**Single Failure Proof Crane Design Topical Report – Post-submittal Meeting
Presentation**

**on
February 19, 2014**

EDR-1: Topical Report Single Failure Proof Crane Design NRC Post-Submittal Meeting Jason Schulz, Crane Product Manager, WEC

AP1000 Design Hierarchy

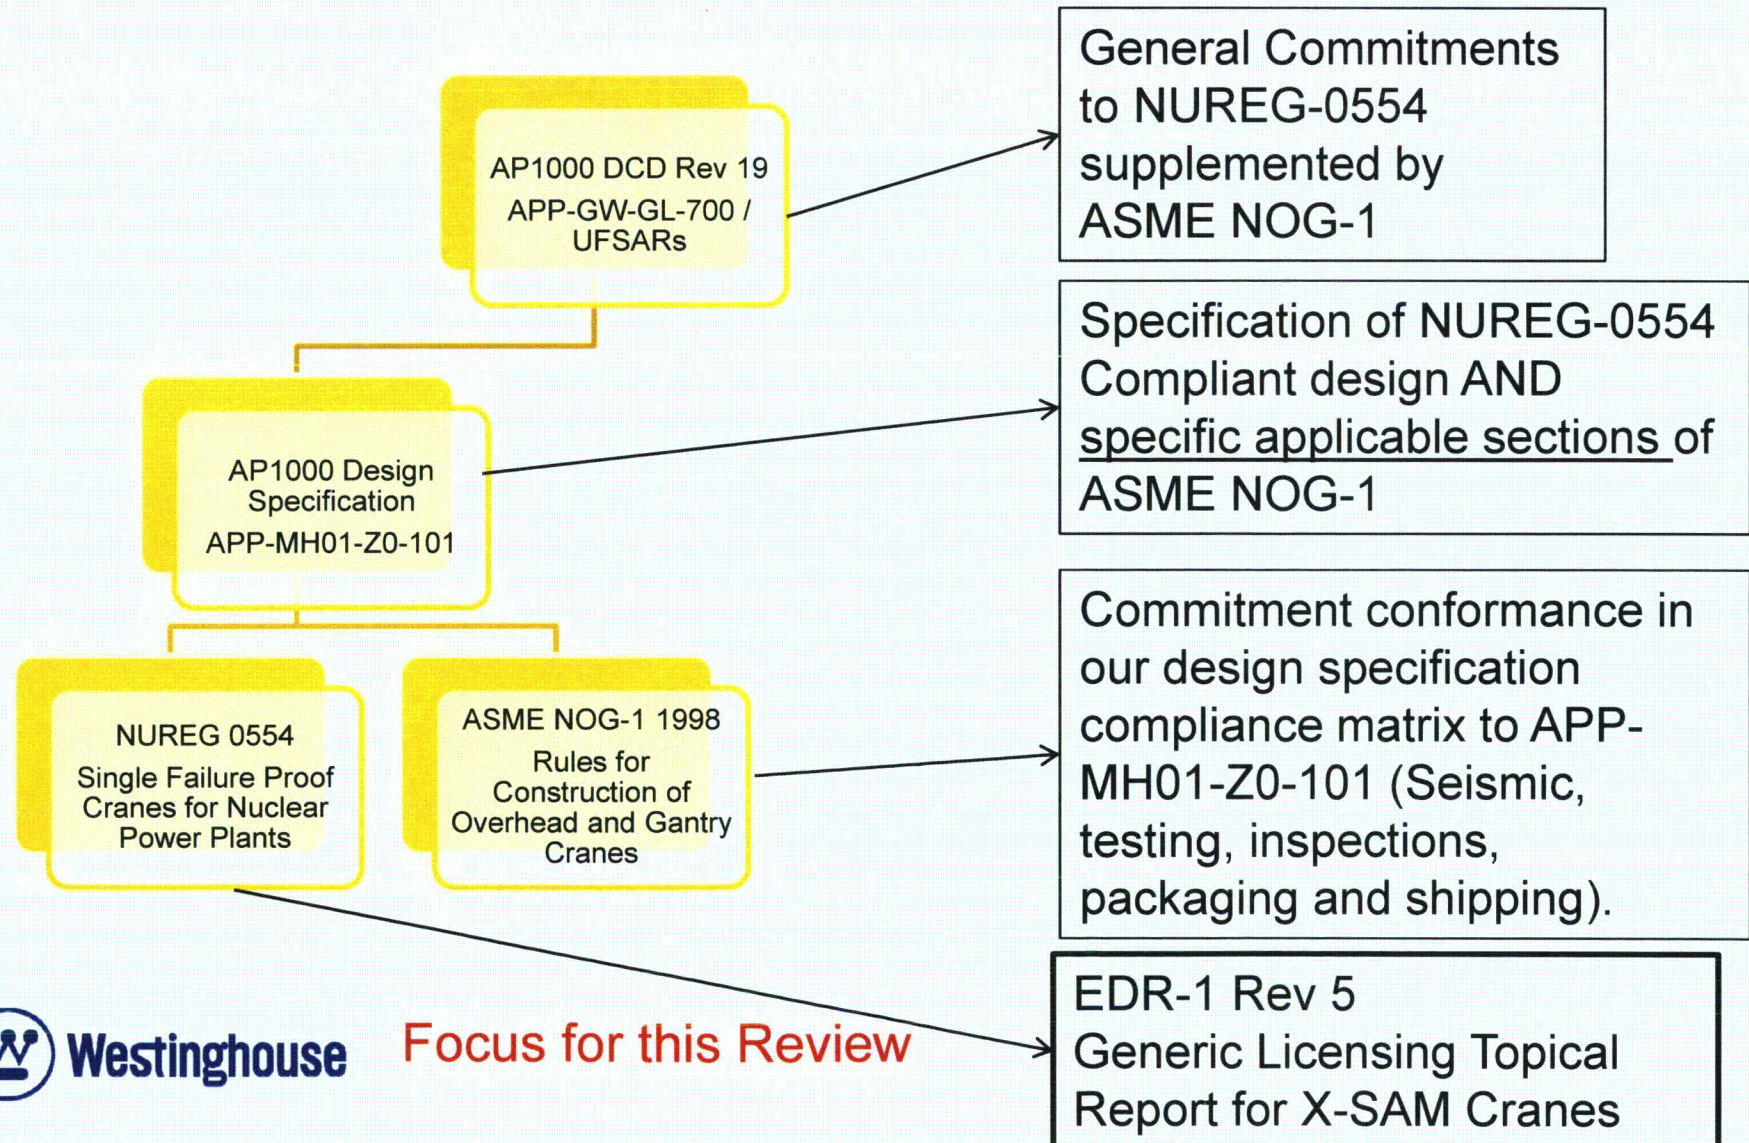
- Comment 1:

TR does not clearly address the use of current NRC guidance for safety-related, single failure proof cranes. Instead, the TR focuses on demonstrating compliance with RG 1.104 criteria, which was withdrawn and replaced by NUREG-0554. The current AP1000 COL applicants do not reference nor commit to use of RG 1.104 criteria. This complicates the review in order to determine whether pertinent guidance of NUREG-0554, NUREG-0612 and NOG-1 have been addressed for the single failure proof design for use in new nuclear power plants. The staff expects that requests for additional information (RAIs) will be needed to develop a full understanding.

- Response:

Single failure proof cranes are not safety related by definition or application of NUREG 0554 and/or NOG-1 alone. The original basis for EDR-1 was RG1.104, however the applicability and relevance of EDR-1 has always been evaluated by the NRC against NUREG 0554. This can be found in the two prior acceptance letters by the NRC, one for REV 1 and one for REV 3. Compliance to NUREG 0554 is specifically stated throughout the document. References to RG1.104 in the TR exist and should primarily be viewed as historical markers to the origin of the initial design objectives for the single failure proof hoists only.

For background, RG1.104 was more stringent than its predecessor NUREG 0554.
